Notice of Meeting of the Historic and Architectural Review Commission of the City of Georgetown, Texas September 24, 2026

File Number: 2026-48-COA

Project Name: *Texas Municipal Center*
Applicant: *Texas Municipal League Intergovernmental Risk Pool, c/o Jeffrey Snyder*
Property Owner: *Texas Municipal League Intergovernmental Risk Pool*
Property Address: *205 E. University Ave.*
Legal Description: *1.322 acres, Block 23, Lots 1-8, Glasscock Addition*
Historic Overlay: *Downtown Area I*
Case History: *October 9, 2025 – Pre-Conceptual Review by HARC*
Prior COA Denials: N/A
Prior COA Approvals: *2026-4-COA for demolition of exterior façade, & penthouse*

**Re: Letter of Intent
HARC New Exterior Façade & Building Additions Certificate of Appropriateness (COA)
205 E. University Ave.
Georgetown, TX 78626**

Before & After – South Elevation

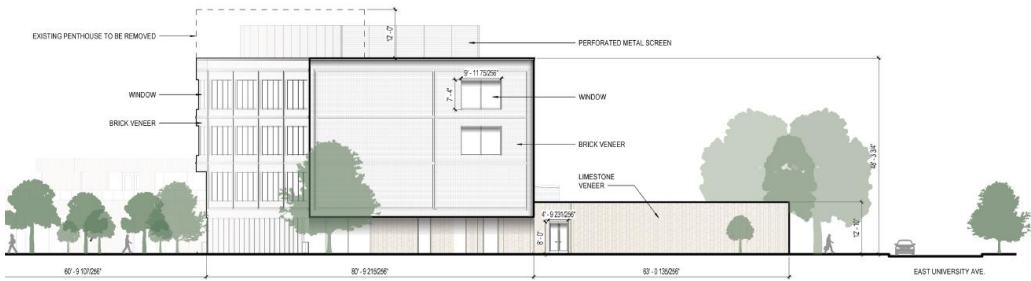
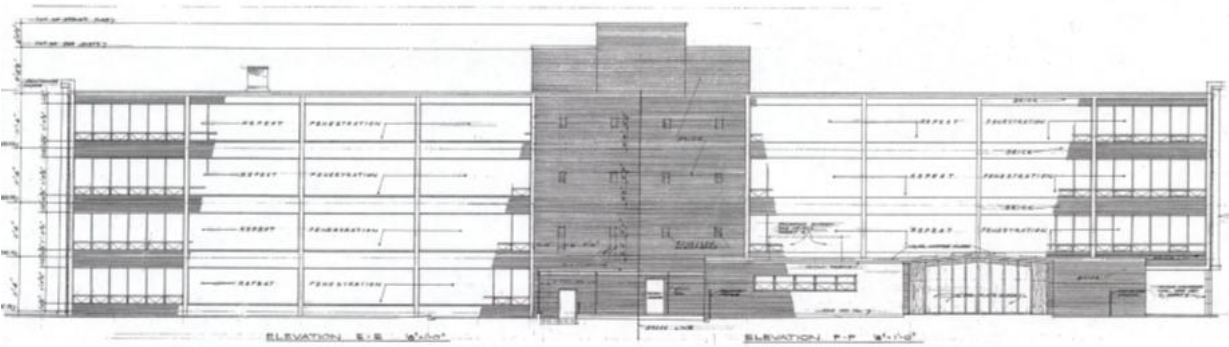
The two proposed additions reinforce the building's early Mid-Century Modern character through their rounded edges and subordinate scale which stands to complement the existing open-v form. Traditional materials found throughout the surrounding historic context, including brick, limestone, and wood, are incorporated into the design. The brick banding will be reintegrated into the primary structure, while the limestone, which was introduced during the 2010 alterations, will be carried into the proposed additions. The primary entrance remains oriented towards 11th Street and is well defined through a break in the brick banding, and a change in material and window composition. The proposed single-lite ribbon windows are also consistent with the existing character of the structure.

6. New buildings or additions are designed to be compatible with surrounding properties in the applicable historic overlay district;	Complies The proposed additions provide a subtle nod to the unique rounded form of the primary historic structure. Located toward the sides of the building and limited to approximately half the height of the existing façade, the additions remain visually subordinate to the primary historic structure while complementing its distinctive architectural form.
